Contract #: 04-0120F4Cty: SF/ALA Rte: 80 PM: 13.2/13.9File #: 69.25B**QUALITY ASSURANCE -- NON-CONFORMANCE REPORT****Location:** Changxing Island, Shanghai, P.R. China**Report No:** NCR-000959**Prime Contractor:** American Bridge/Fluor Enterprises, a JV**Date:** 28-Dec-2010**Submitting Contractor:** Zhenhua Port Machinery Company, Ltd (ZPMC), Changxing Island**NCR #:** ZPMC-0918**Type of problem:**

Reference Description: QA found 2 missed transverse UT indications in Lift 13AE Bottom Panel to Side Panel splice

Job Name: SAS Superstructure
Document No: 05.03.06-000916

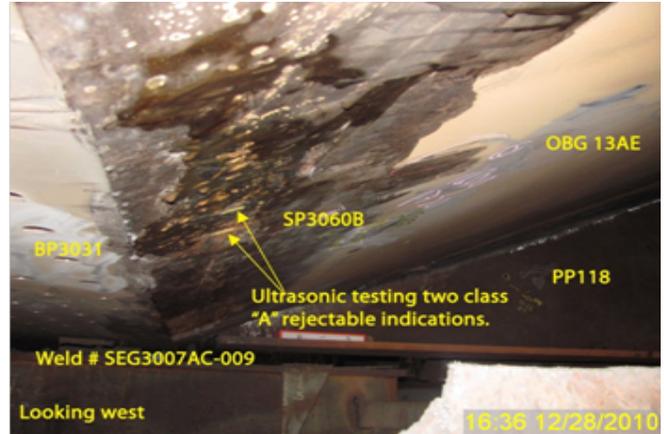
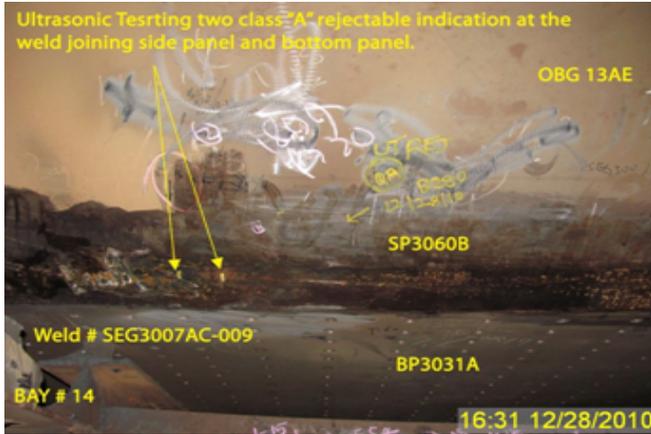
During the Quality Assurance (QA) Ultrasonic Testing (UT) review of welds located on Orthotropic Box Girder (OBG) Segment 13AE, this QA Inspector discovered the following issues:

- Two (2) transverse linear Class "A" rejectable indications measuring approximately 10 and 8mm in length.
- The weld is identified as SEG3007AC-009.
- Material thickness is 22mm.
- The depths of the indications are approximately 17 and 15mm respectively.
- The indications dB ratings are -5 and -1 respectively.
- The weld is Complete Joint Penetration (CJP) corner joints, joining bottom plate to side plate.
- Bottom plate identified as BP3031A
- Side plate identified as SP3060B
- The welds are not designated as Seismic Performance Critical Material (Non SPCM).
- The indications are clearly marked near the welds.
- The Y distances measured approximately 1720 and 1800mm respectively.
- The OBG segment 13AE is located in the bay 14.

The Notice of Witness Inspection (NWIT) No. is 007956. The indications are located within an area previously tested and accepted by ZPMC Quality Control (QC) personnel. As per the contract documents, ZPMC's QC personnel are required to perform 100% UT inspection of these welds.

AWS D1.5-02 Section 6; Table 6.3 specifies a class "A" indication as having a rating of 8dbs and under for material thicknesses 20mm through 38mm.

ZPMC acknowledged this problem and has issued an internal NCR. ZPMC has repaired the indications noted in the NCR and is providing NDT documentation after the repair to show the indication has been removed. ABFJV has noted which inspector was responsible for this missed indications and is monitoring his performance as well as all inspector performance, if he continues to miss indications disciplinary action will be undertaken. Based on these actions, ZPMC requests closure of this NCR.

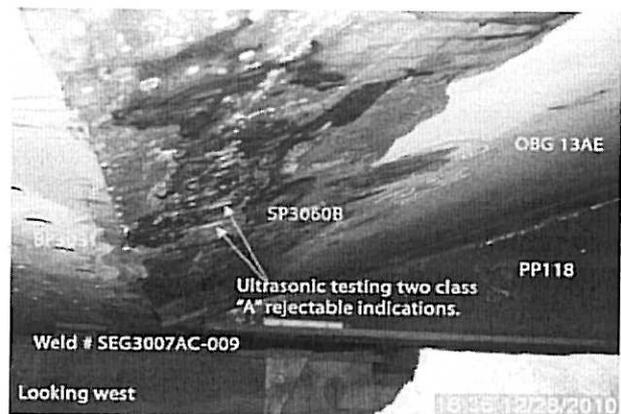
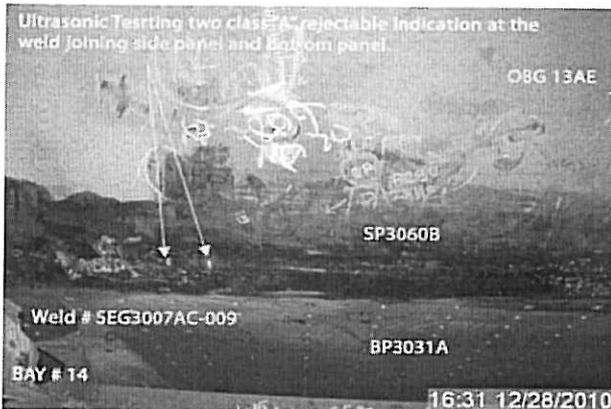
During the Quality Assurance (QA) Ultrasonic Testing (UT) review of welds located on Orthotropic Box Girder (OBG) Segment 13AE, this QA Inspector discovered the following issues:

- Two (2) transverse linear Class "A" rejectable indications measuring approximately 10 and 8mm in length.
- The weld is identified as SEG3007AC-009.
- Material thickness is 22mm.
- The depths of the indications are approximately 17 and 15mm respectively.
- The indications dB ratings are -5 and -1 respectively.
- The weld is Complete Joint Penetration (CJP) corner joints, joining bottom plate to side plate.
- Bottom plate identified as BP3031A
- Side plate identified as SP3060B
- The welds are not designated as Seismic Performance Critical Material (Non SPCM).
- The indications are clearly marked near the welds.
- The Y distances measured approximately 1720 and 1800mm respectively.
- The OBG segment 13AE is located in the bay 14.

The Notice of Witness Inspection (NWIT) No. is 007956. The indications are located within an area previously tested and accepted by ZPMC Quality Control (QC) personnel. As per the contract documents, ZPMC's QC personnel are required to perform 100% UT inspection of these welds.

AWS D1.5-02 Section 6; Table 6.3 specifies a class "A" indication as having a rating of 8dbs and under for material thicknesses 20mm through 38mm.

Contractor will remove the indications and repair the weld, providing the NDT report to prove the weld is acceptable. ZPMC will issue an internal NCR to the QC personnel involved and monitor his performance, taking disciplinary actions if he continues to miss indications.

Contractor removed the indications and repaired the weld, and provided the NDT reports to prove the weld is acceptable. Contractor issued an internal NCR to the QC personnel and monitor his performance.
